RE: **2-ZN-2023**
Swags
H5018 (Key Code)

Planning & Development Services has completed review of the above referenced development application submitted on 3/10/2023. The following comments represent issues or deficiencies identified by the review team and are intended to provide you with guidance for compliance with city codes, policies, and guidelines.

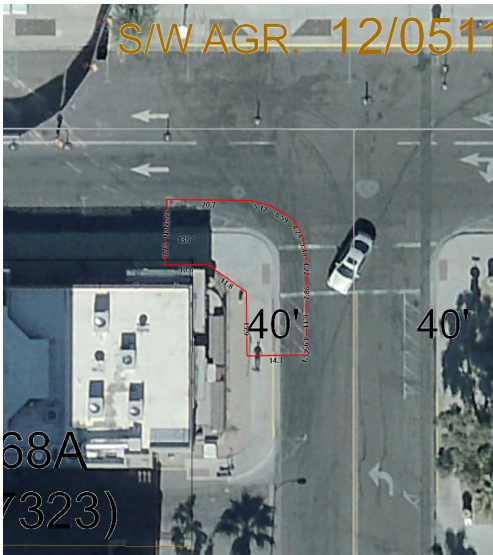
15. Please revise the site plan to reconfigure the curb line at the corner of Shoeman and Wells Fargo so that the curb bulbs out around the on-street parking spaces at the corner. Please see exhibit below for reference.
